CORRECTIONS TO THE LETTER OF DETERMINATION FOR THE FOURTH AND CENTRAL PROJECT; CASE NO. VTT- 82974-CN-HCA-1A; CF 26-0047-S1

On December 15, 2025, the City Planning Commission issued a Letter of Determination denying the appeal and sustaining the decision of the Advisory Agency to approve Vesting Tentative Tract Map (VTTM) No. 82974-CN-HCA for the Fourth and Central Project (Project). The grant clause of the VTTM approval letter cited the tract map dated April 21, 2021. However, the approved map for the Project included minor discrepancies and errors in the proposed ground lot sizes. A revised tract map dated August 21, 2025 was submitted, correcting Ground Lot 2 from 14,042 square feet to 14,043 square feet and Ground Lot 4 from 146,503 square feet to 148,503 square feet. Therefore, the grant clause should be updated with the revised date. Additionally, Condition of Approval No. 51 references an outdated Hydrants & Access review date from the Los Angeles Fire Department (LAFD), and Subdivision Map Act Finding (b) references unclear information about street widening on Alameda Street where dedication to the public right of way is required, but no roadway widening is required. There

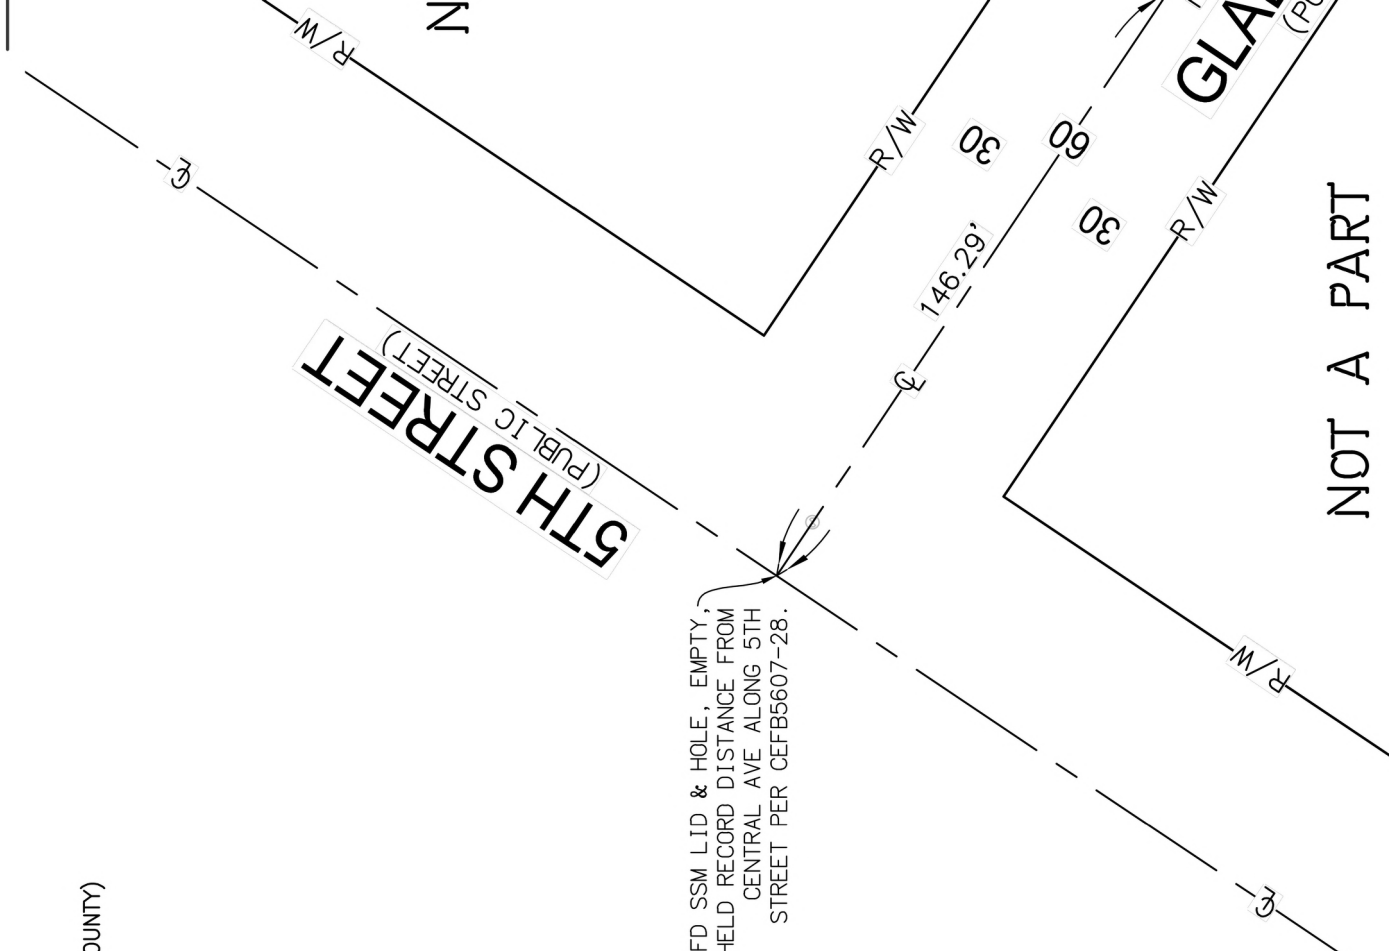
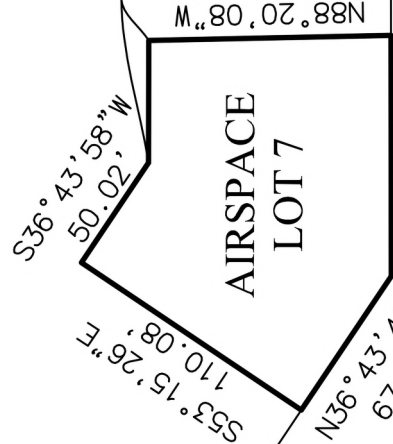
3. **Approved**, pursuant to Sections 17.03 and 17.15 of the Los Angeles Municipal Code (LAMC), a Vesting Tentative Tract Map No. 82974-CN-HCA (stamped map, dated **April 21, 2021** **August 21, 2025**) for the merger and re-subdivision of the site into four ground lots and 27 airspace lots and for condominium purposes, and a Haul Route for the export of up to 651,000 cubic yards of soil;
